noel griffith, jr.
& associates
architects

Boys and Girls Club
Multi-Purpose Bldg.
Addendum Number One
February 15, 2013

**MULTI-PURPOSE BLDG.
BOYS AND GIRLS CLUB**
 CHEYENNE, WYOMING

TOP OF MASONRY DETAIL

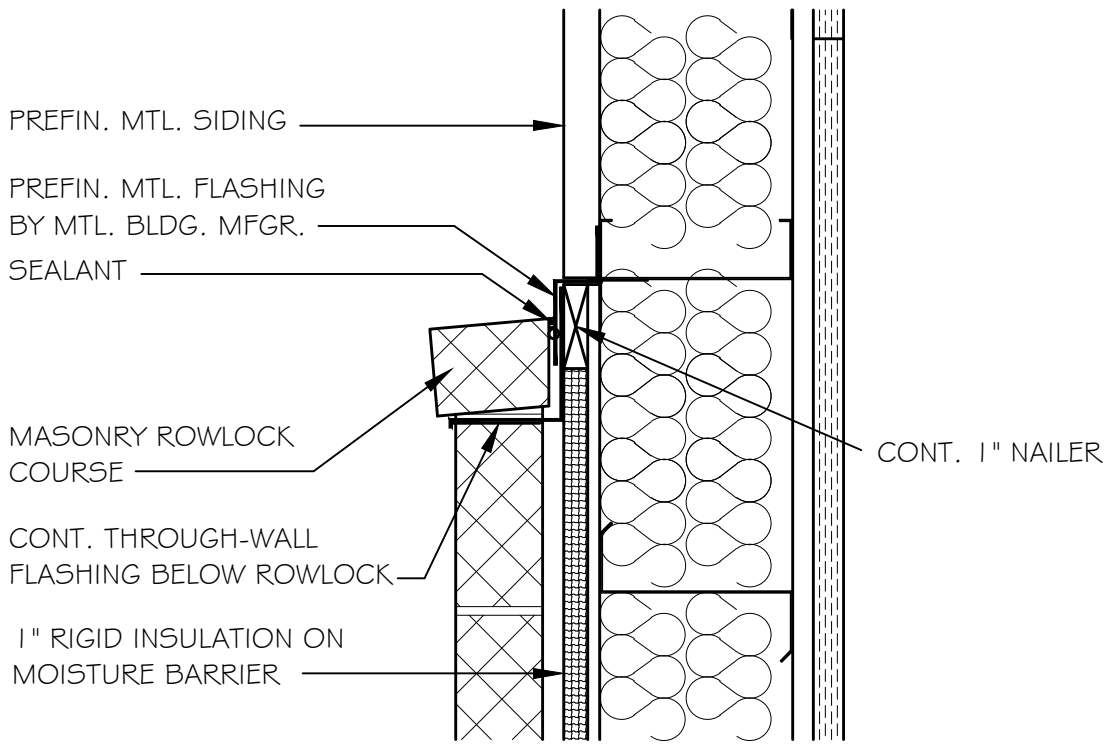
3. Sheet A6, Wall Sections: Install continuous through-wall flashing with weep holes every 32" at horizontal masonry joint at floor level, and below rowlock course at top of masonry. See attached Sheet AD-1 for top of masonry detail. Install galvanized steel joint reinforcement at 16" o.c. in masonry veneer.
